SUBJECT: COMANCHE PEAK STEAM ELECTRIC STATION UNIT 1
DOCKET NOS. 50-445 AND 50-446
REQUESTED CHANGES TO FINAL DRAFT
TECHNICAL SPECIFICATIONS

ATTACHMENT TO TXX-4360

The following is a partial list of requested changes to the Comanche Peak Final Draft Technical Specification of September 4, 1984:

FIGURE 6.2-1

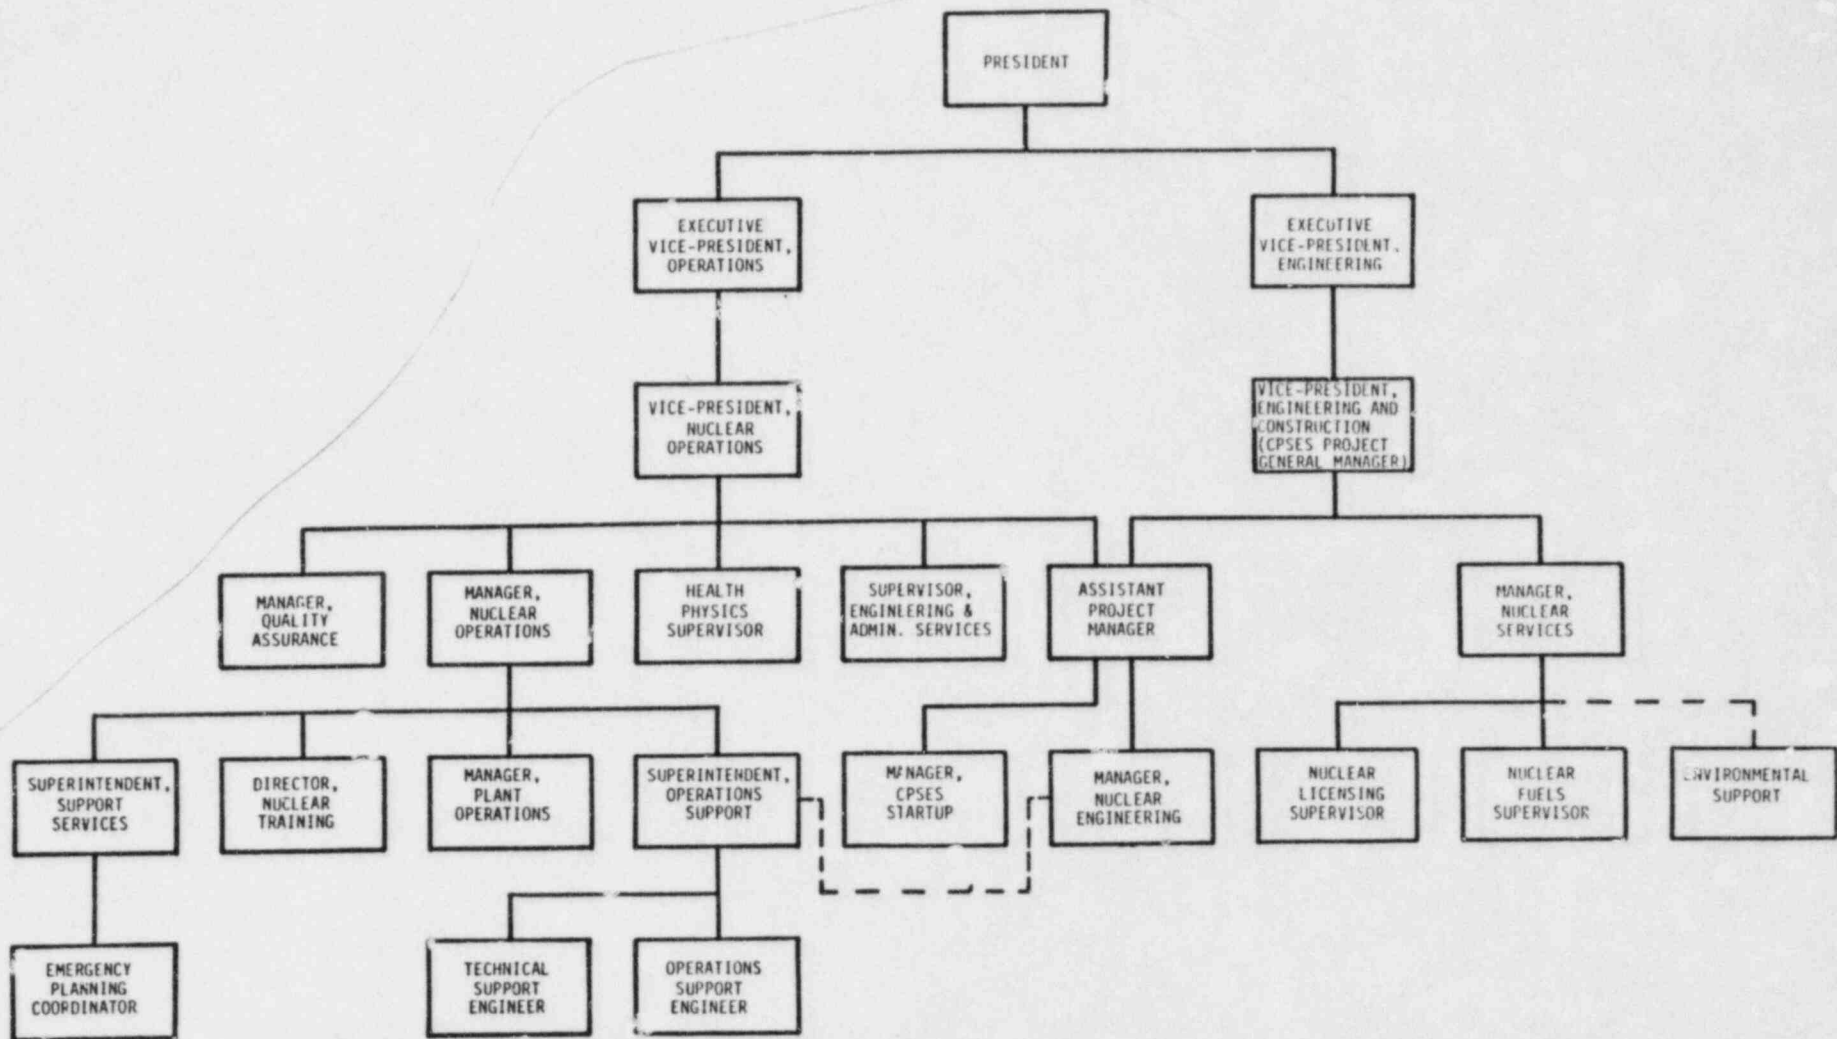
3. Enclosed are new figures 6.2-1 and 6.2-2.
4. Enclosed is a mark up of ESF Response Times Table 3.3-5. The changes have been discussed with the staff and verified against safety analyses and systems design.
